# **Modification Comment for GATE Message**

**LEE Ho-Sook ETRI  
Yoo Tae-Whan ETRI  
Son Kyu-Ho KAIST  
Jeong Song KAIST**

# Proposed modification of draft ver 1.2

### ✓ Fig. 56-31

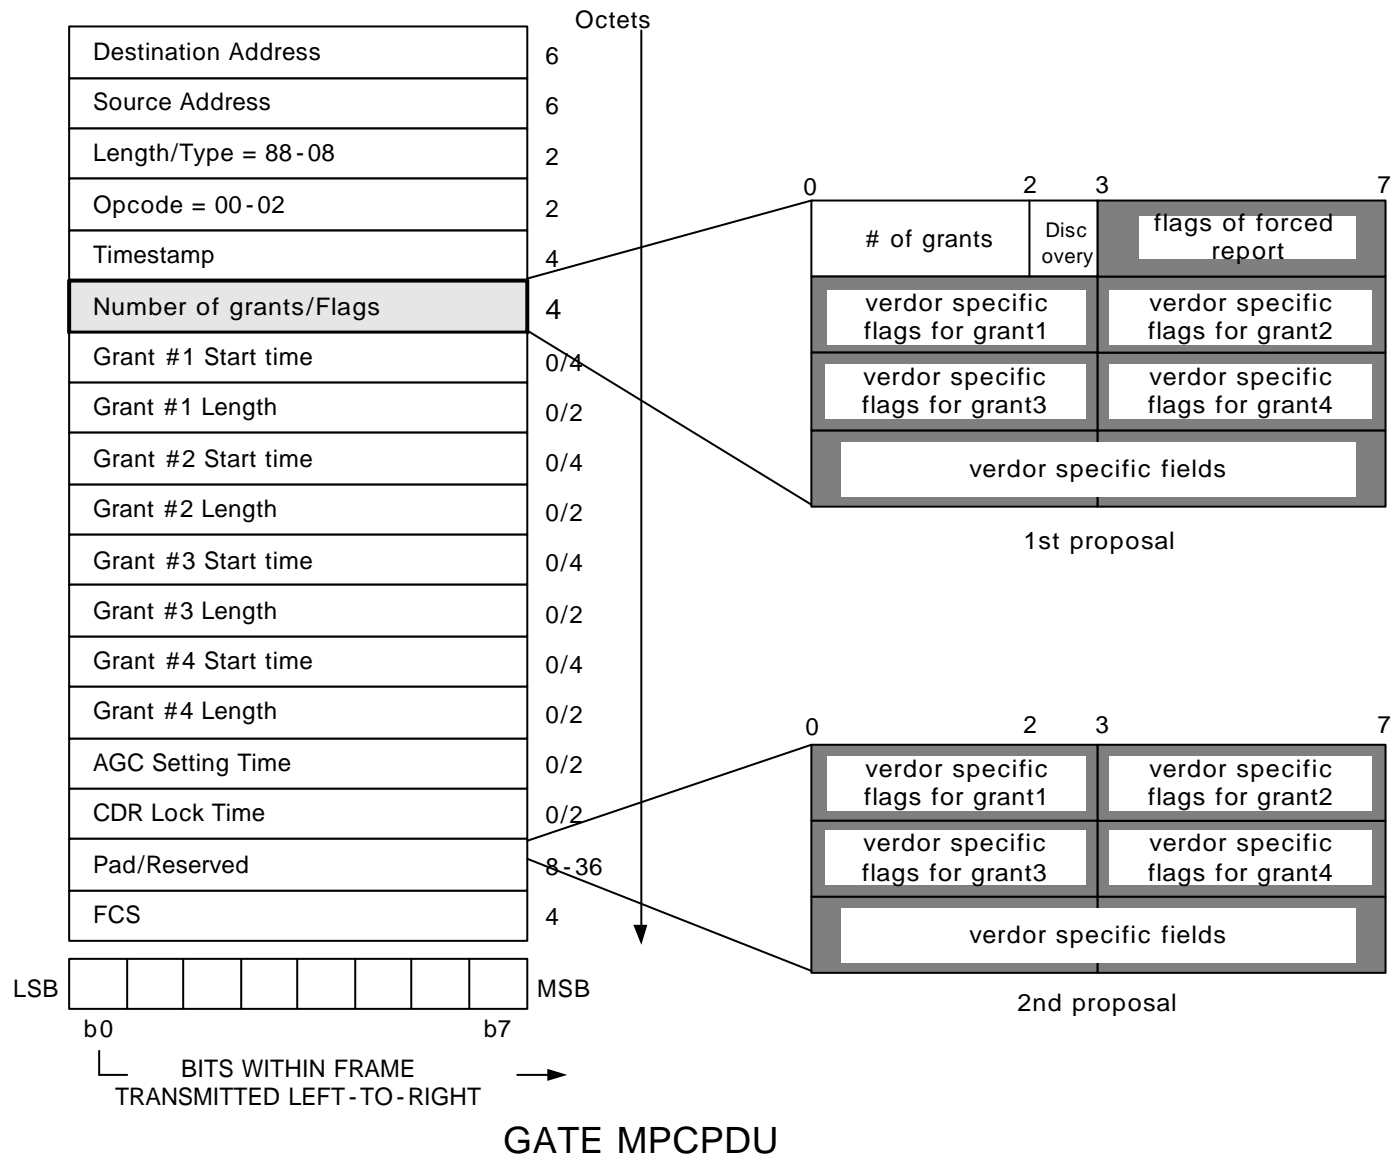
- 1<sup>st</sup> proposal : Change 1 byte “number of grants/flags” field to 4 bytes
  - 0-2 bit : # of grants
  - 3 bit : discovery gate / normal gate
  - 4-7 bit : flags for forced report
  - 2 bytes : 4bit flags for vendor specific extension (4bit flags \*4 grants info.)
  - 1 byte : vendor specific information
- 2<sup>nd</sup> proposal : Insert 3 bytes of “vendor specific fields” into “Pad/Reserved” field
  - 2 bytes : 4bit flags for vendor specific extension (4bit flags \*4 grants info.)
  - 1 byte : vendor specific information
